STATE OF WASHINGTON  
DEPARTMENT OF ECOLOGY

Re: 100-BC-1 Chapter 1 and Chapter 5 Inadequacies

## COMMENTS ON THE FEBRUARY 10, 1992

## UNIT WORK PLAN

Chapter 1 Flow Chart

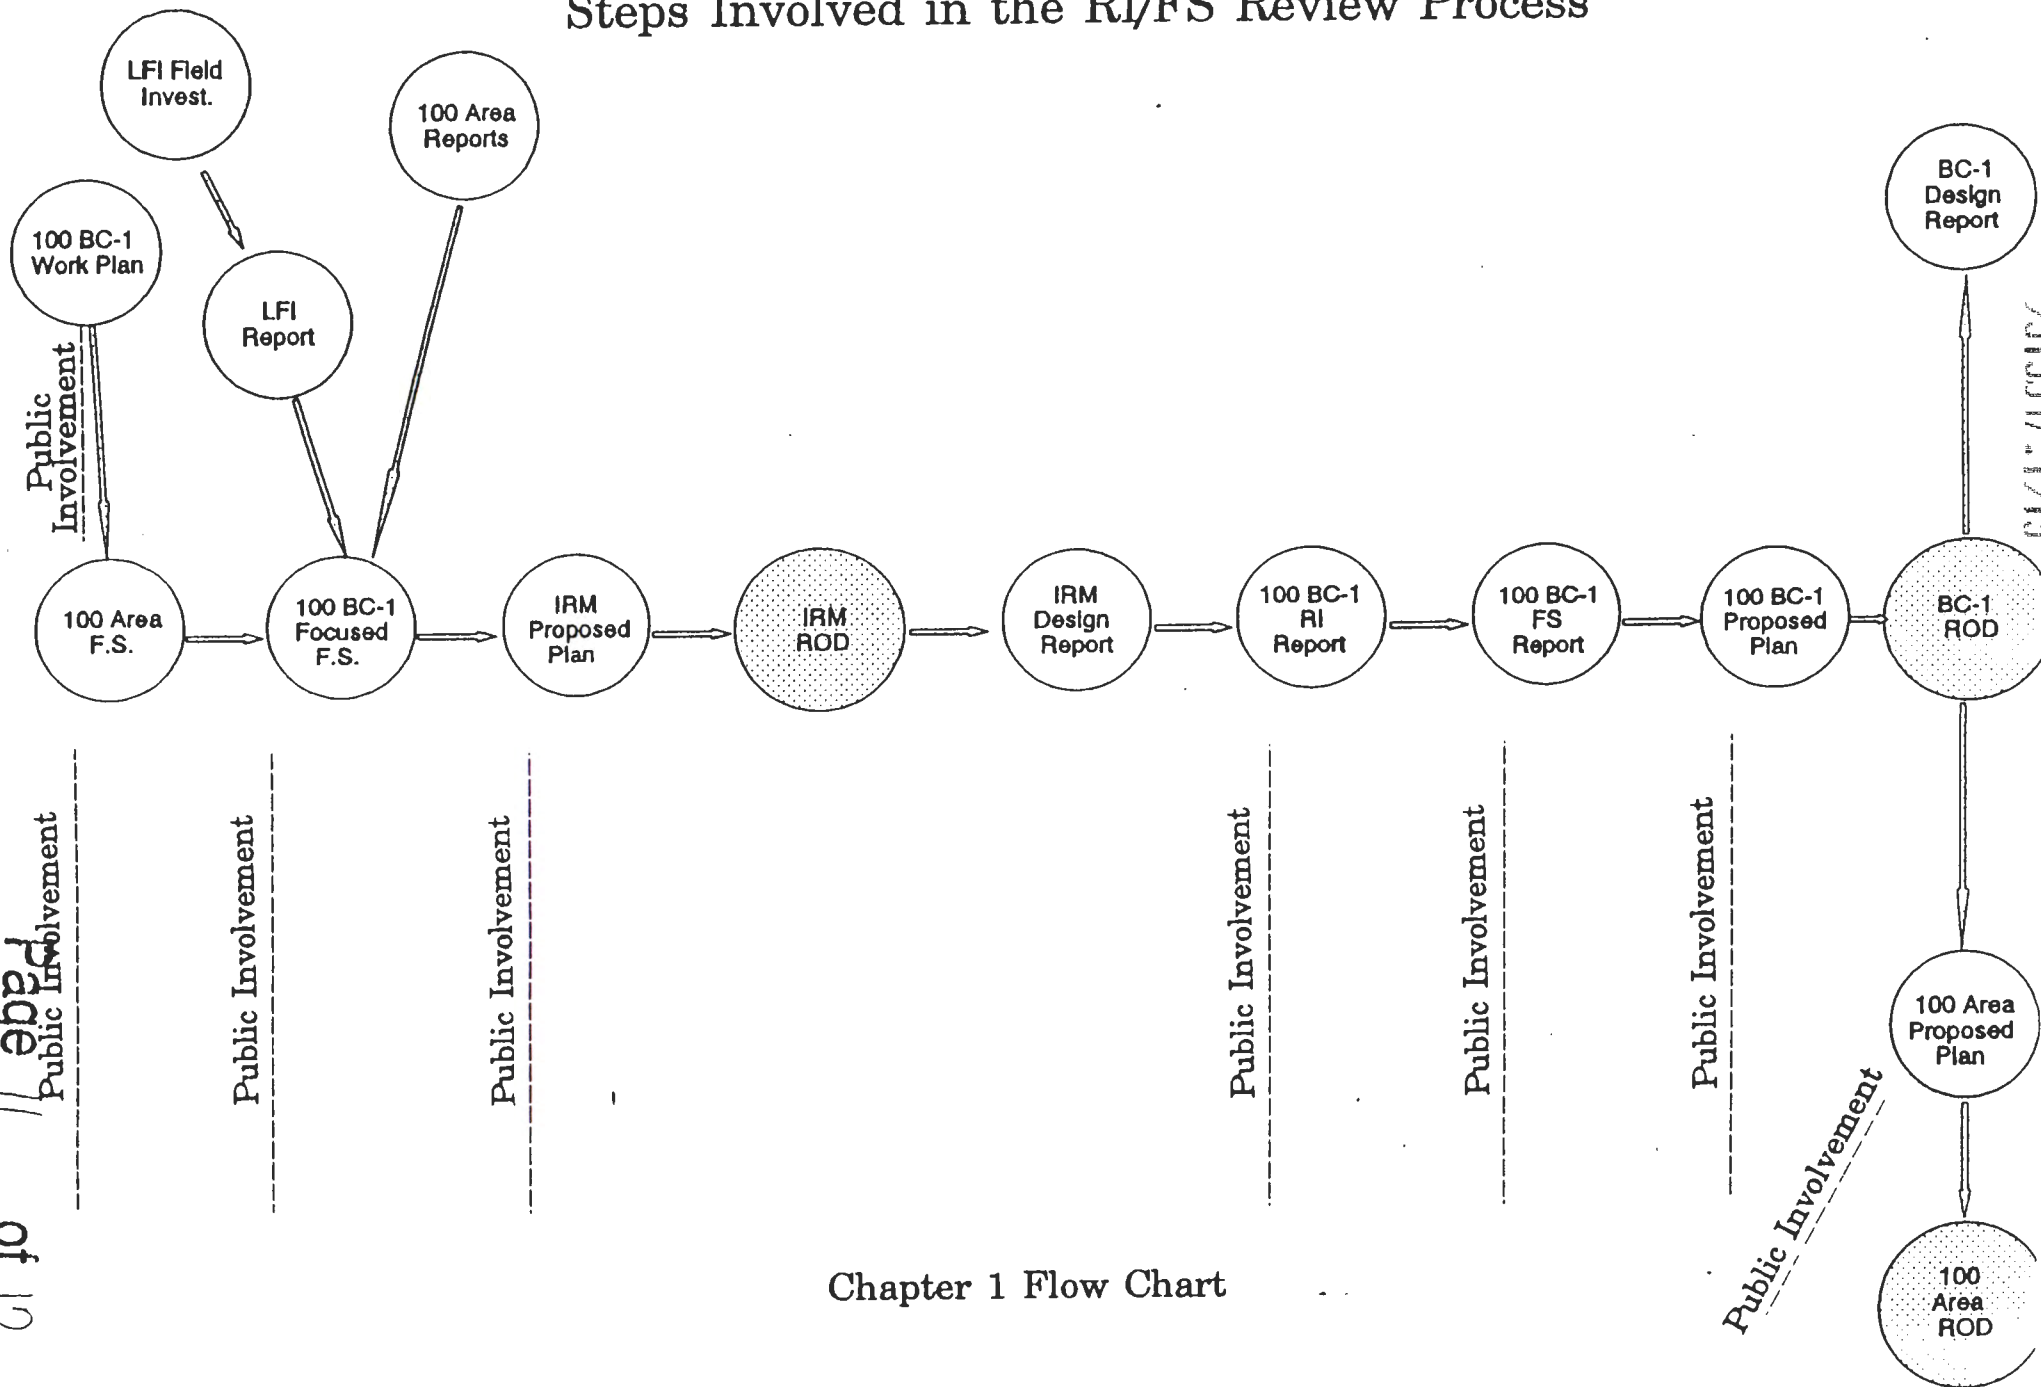
Deficiency: This process is so complex that a flow chart should be attached.

Recommendation: Attach the enclosed flow chart "Chapter 1 Flow Chart", to help clarify this section.
